CERTIFICATE OF APPROPRIATENESS

Property: 525 Bayland Avenue, Lot 9, Block 20, Woodland Heights Subdivision. The property includes a historic 1,798 square foot, one-story wood frame single-family residence situated on a 5,000 square foot (50' x 100') corner lot.

Proposal: Alteration – At the June 13, 2013 the Commission approved a COA for a rear two story addition to a one-story contributing residence. The applicant has revised the plan and submitted the following for consideration:

WEST SIDE ELEVATION FACING NORTHWOOD STREET

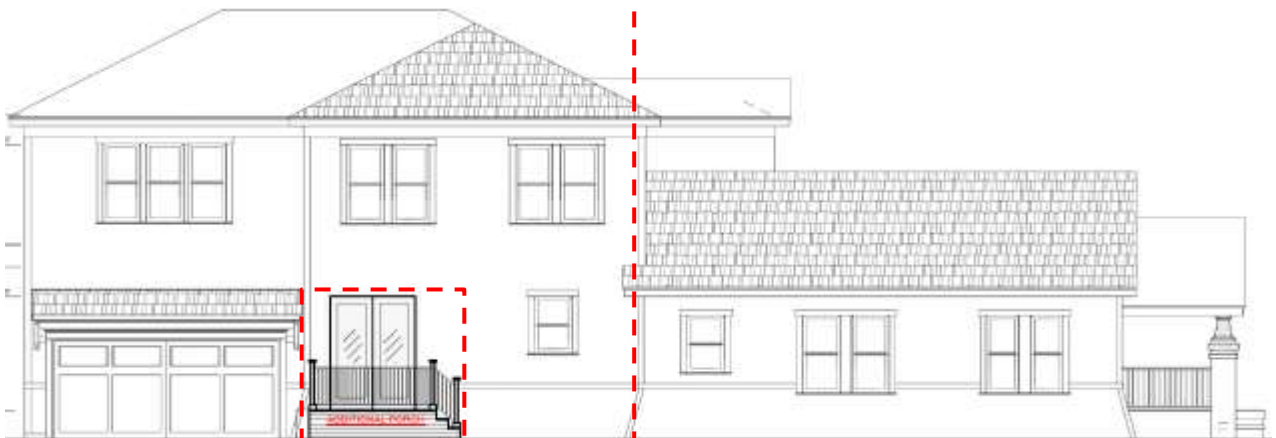
- Install a set of single lite french doors and construct a porch measuring 9' wide and 4'-6" deep on the west elevation of the rear addition facing Northwood Street.

Side Elevation: The proposed addition will feature a set of single lite french doors (previously approved two 1-over-1 wood sash windows) and a porch featuring wood steps, handrails, and guardrails.
(West)

FIRST FLOOR PLAN

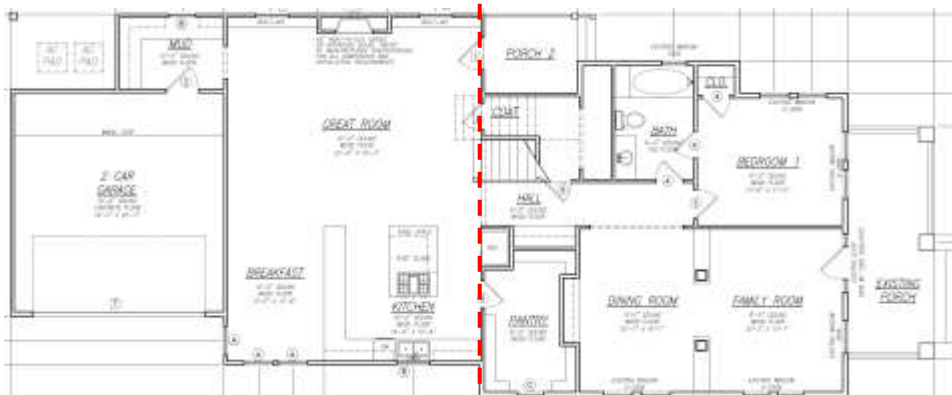
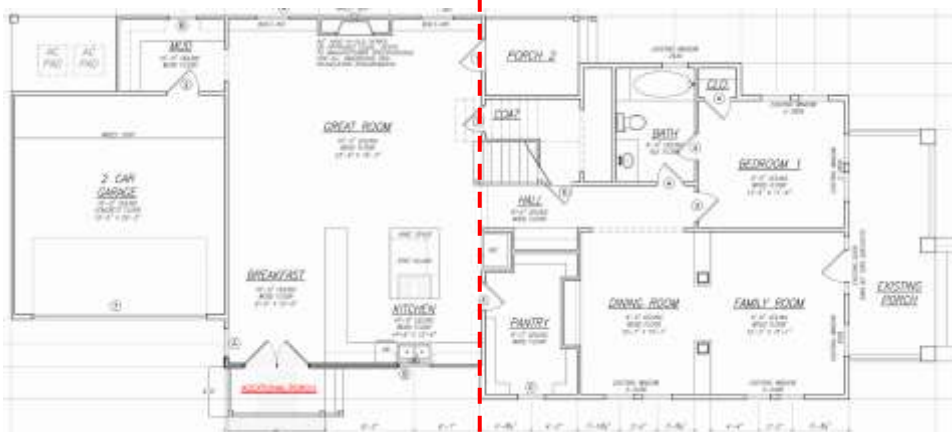
Shape/Mass: The proposed addition will feature a side porch measuring 9' wide and 4'-6" deep. The porch will measure 2' in height.

Windows/Doors: Install a set of single lite french doors on the proposed addition (previously approved two 1-over-1 sash windows).
